DSX OPENER (2ND GENERATION)

HORIZON

DSX 2ND GENERATION OPENER | PRODUCT INFORMATION | v1.0

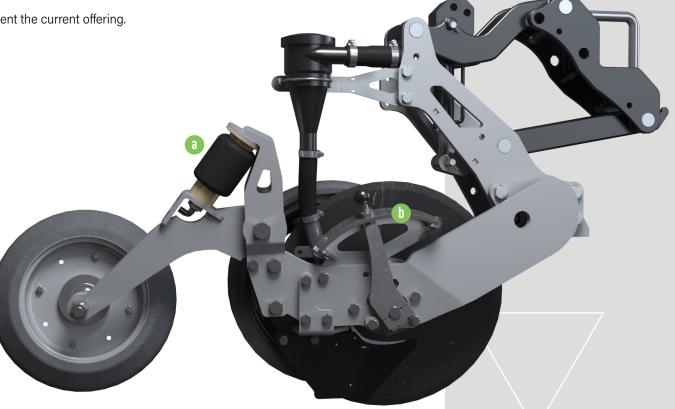
- In moving to side gauge depth control we have now added a pneumatic airbag to the rear closing arm. This offers the operator the ability to set the closing pressure separately to the opener downforce. The pressure adjustment is controlled from the tractor cabin.
- The pneumatic system gives a minimum of 6kg and a maximum of 90kg of closing force.

Resulting in a flexible solution for farmers facing tough no-till / min-till or loose soil conditions.
- The operator's manual will give a clear indication of the maximum closing pressure to run, relative to hydraulic downforce on the openers.
